APPEAL SUMMARY

Appeal ID: 26452	Project Address: 8671 SE Washington St
Hearing Date: 1/26/22	Appellant Name: Sara Mahoney
Case No.: B-010	Appellant Phone: 971-285-2001
Appeal Type: Building	Plans Examiner/Inspector: Natalie Luttrell, Jason Buerkle
Project Type: residential	Stories: 2 Occupancy: Residential Construction Type: V-B
Building/Business Name:	Fire Sprinklers: No
Appeal Involves: Erection of a new structure, Alteration of an existing structure	LUR or Permit Application No.: 20-176884-RS
Plan Submitted Option: pdf [File 1] [File 2]	Proposed use: Duplex

Appeal item 1

Alternate 1 hour North and South wall assembly: Granted provided continuity of 1 hour construction is verified at time of plan review.

3 1-HR EXTERIOR WALL (AT GARAGE)
ASSEMBLY: 100 MIN PER TABLE
FIRE: 1-HR STC: NR

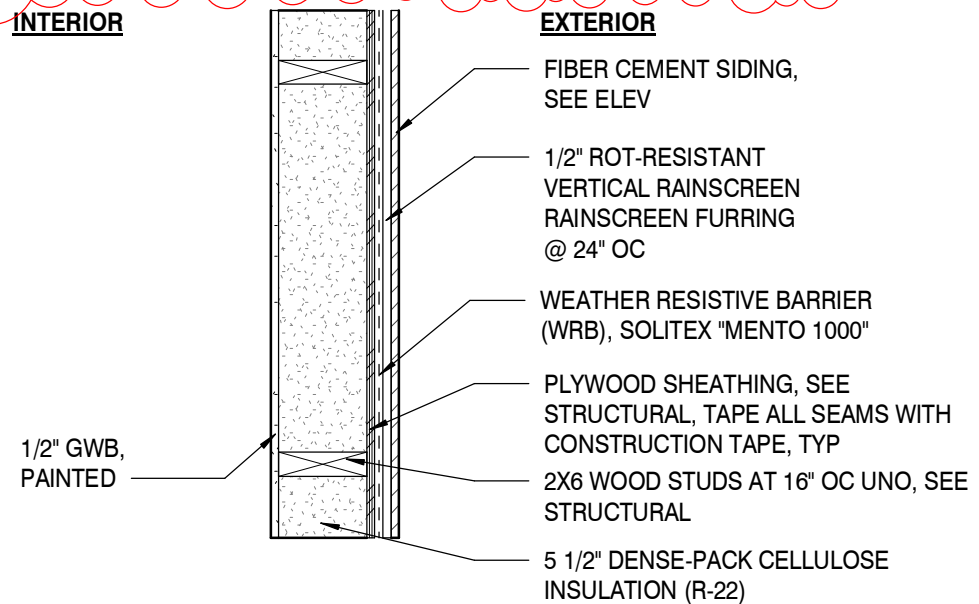
Code Section	R302.1
Requires	<p>Fire rating at exterior wall with less than 3' fire separation: 1 hour—tested in accordance with ASTM E119 or UL 263 with exposure from both sides. This project was permitted under ORSC 2017, but ORSC 2021 has been updated to include the language “or section 703.3 of the Building Code.”</p> <p>Where floor assemblies are required to be fire-resistance rated by Section R302.3, the supporting construction of such assemblies shall have an equal or greater fire-resistance rating.</p>
Code Modification or Alternate Requested	Allow two layers of type 'x' 5/8" gypsum wallboard at interior in lieu of providing type 'x' 5/8" gypsum wallboard at both exterior and interior at the north and south walls of the garage.
Proposed Design	Two layers of type 'x' 5/8" gypsum wallboard at interior in lieu of providing type 'x' 5/8" gypsum wallboard at both exterior and interior at the north and south walls of the garage.

Reason for alternative	<p>The exterior insulation, rain screen and siding have already been installed without the exterior layer of type 'x' 5/8" gypsum wallboard and would be costly to remove, and we propose an alternative wall assembly to achieve the one hour rating. The configuration of units on this site is unique and has been permitted as a duplex.</p> <p>The north garage wall is required to be rated with “equal or greater fire resistance rating” to the floor above per R302.3.1. In this case, the fire risk comes from the interior of the building rather than the exterior as there is no property line or adjacent structure within 3', and complies with Building Official Determination No. 19-01. Two layers of type 'x' 5/8" gypsum wallboard at the interior as we propose in revised assembly 3 with wood studs and dense cellulose insulation</p>

achieves a 100 minute rating according to OSSC 2019 section 703.3. It is also similar to a tested assembly described below.

WS6-1.6 One-Hour Fire-Resistance-Rated Wood-Frame Wall Assembly
(Rated from gypsum wallboard side)

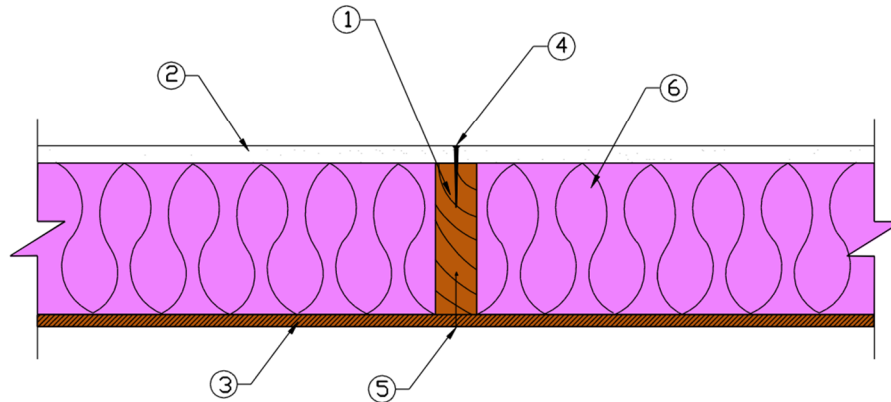
Additionally, a similar assembly with one layer of 5/8" type 'x' gypsum wallboard at the interior and minimum 15/32" wood composite sheathing has been approved by the American Wood Council (see attachment) for one-hour fire rating. Aside from the exterior non-combustible insulation, rainscreen and siding in our assembly, the only difference between our assembly and this assembly is that we propose dense pack cellulose in lieu of fiberglass insulation, which according to table 722.6.2(5) of OSSC 2019 has the same fire resistance as fiberglass. We propose an additional layer of 5/8" type 'x' at the interior for additional fire protection.
